HARTING Product Change Notification

PCN/18/006/C+N

Title: Minor change of DIN rail outlet for RJ45 Keystone jacks - External

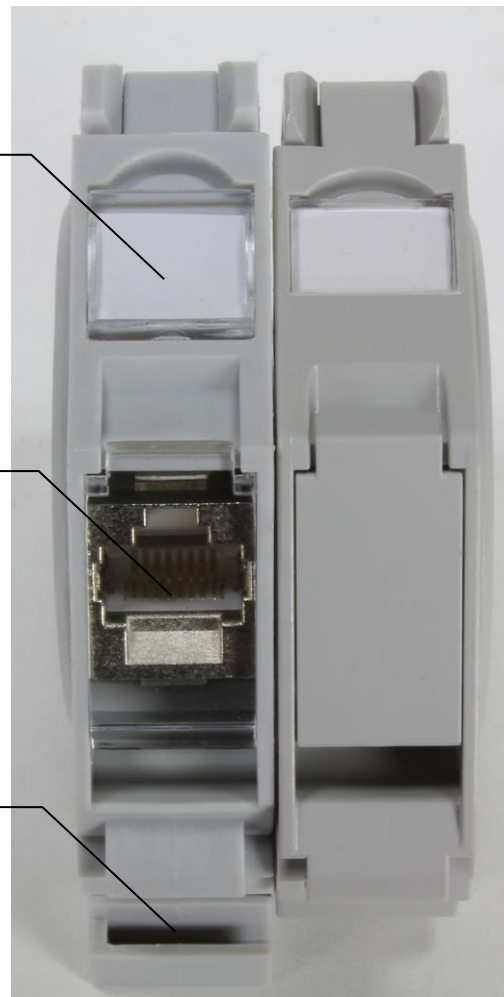
The plastic molding tools needed to be replaced and we use this task to improve some points of the DIN rail outlet design. See picture with the details below.

NEW: Bigger marking area

NEW: Transparent cover

NEW: Improved unlocking area

New desing

Old design

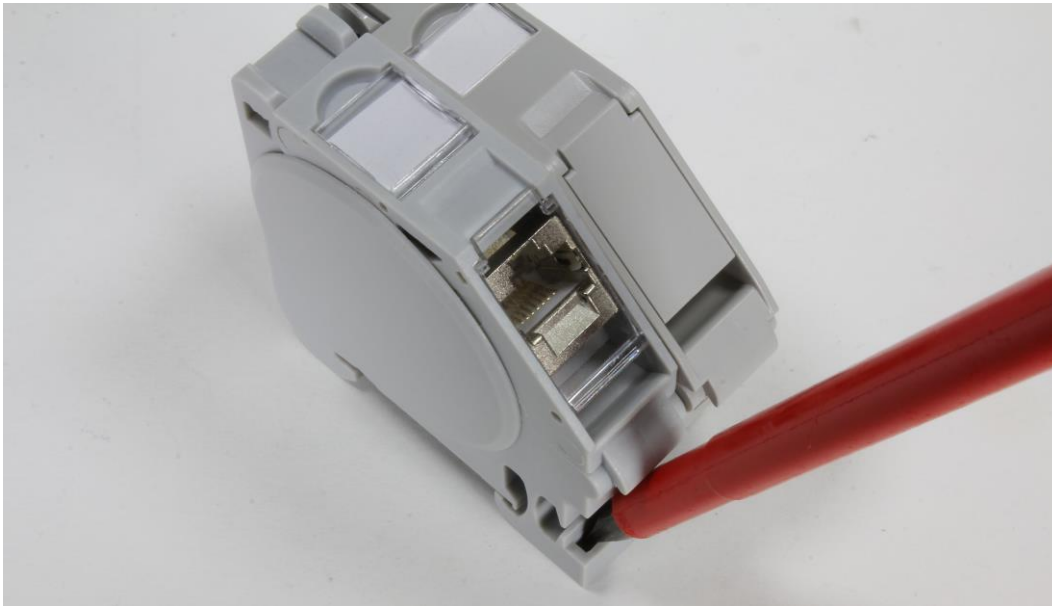
At this picture the improved unlocking area is shown in function with a screw driver to remove the DIN rail outlets from the DIN rail more easily compared to the old design.

All main dimensions are identical as the old design and in this way, we don't have any negative influence to any application.
